TO: David Ploense, Rick Engineering
FROM: Amber Wood Hicken, Planner I
DATE: 7/24/25
SUBJECT: Douglas 234 Dunkin Donuts, Site Plan
Review Comments 05

SITE PLAN FOR
DUNKIN' DONUTS
DOUGLAS 234, FILING NO. 6,
AMENDMENT 1, LOT 4

6TH SUBMITTAL

1 PHOTOMETRIC SITE PLAN
SCALE: 1"=20'-0"

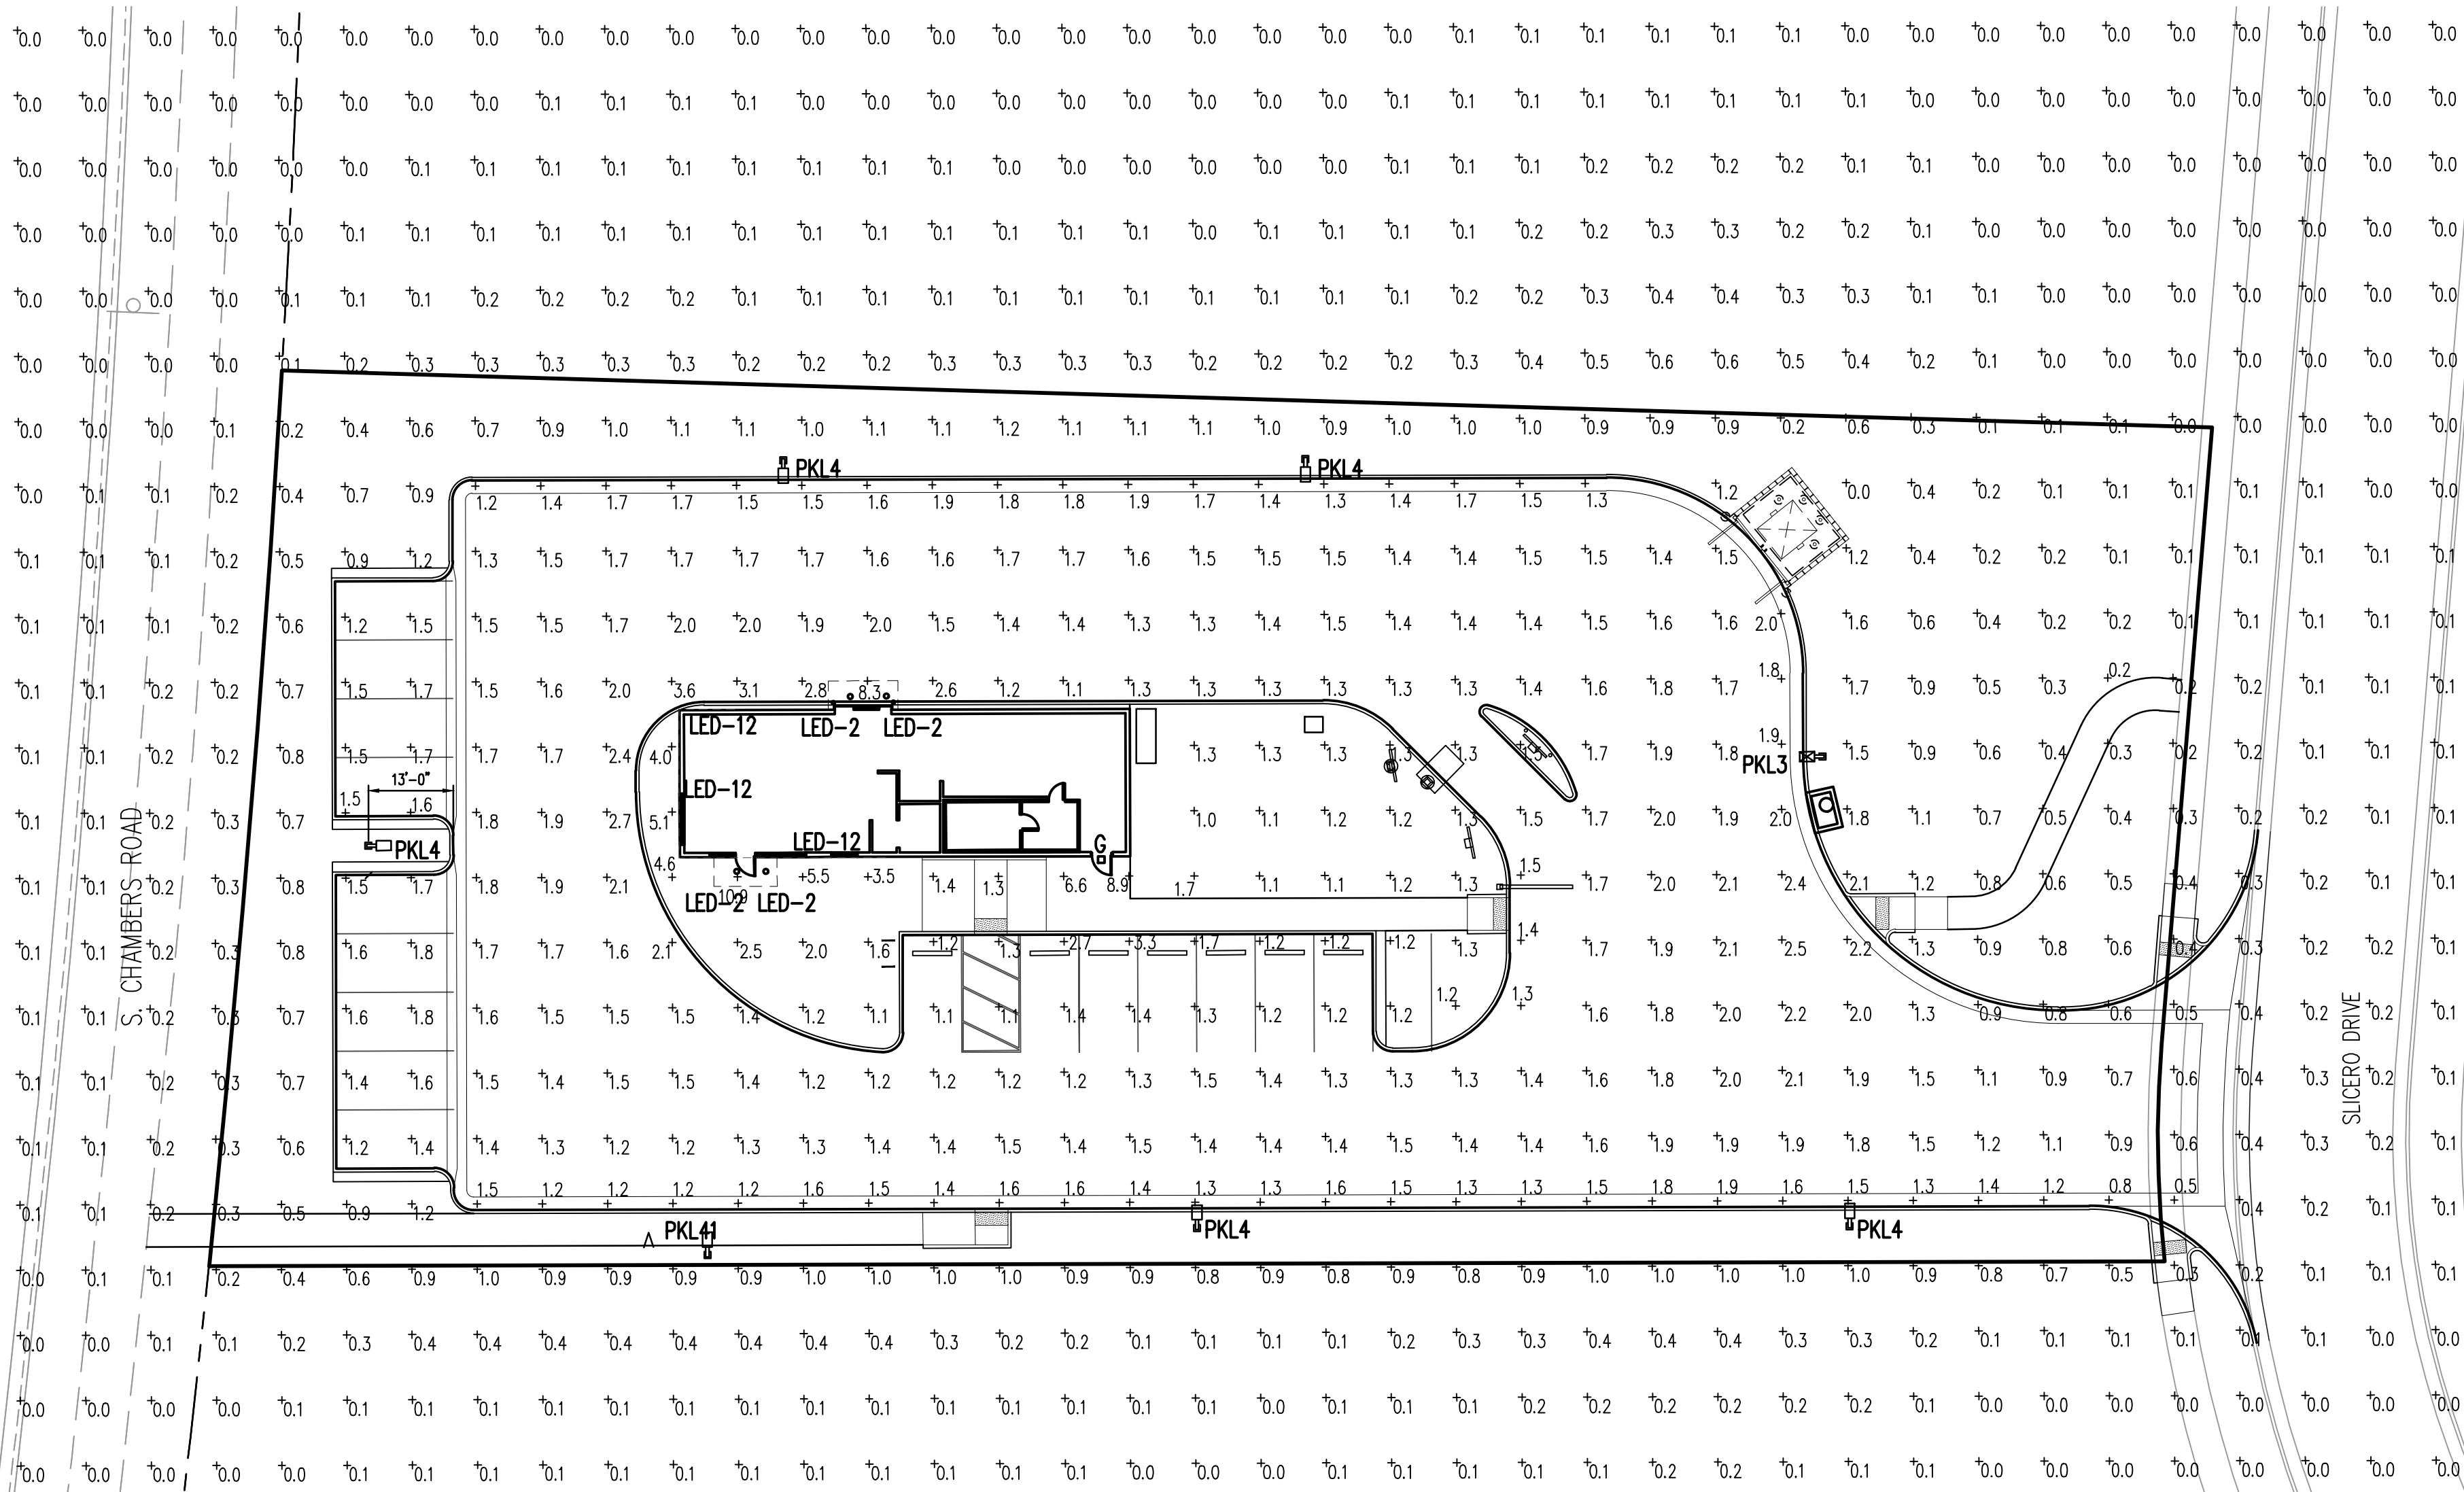
show uniformity ratio for drive aisles and parking lot (should be 6:1 max to min)

Parking and Drive Aisles added to summary.
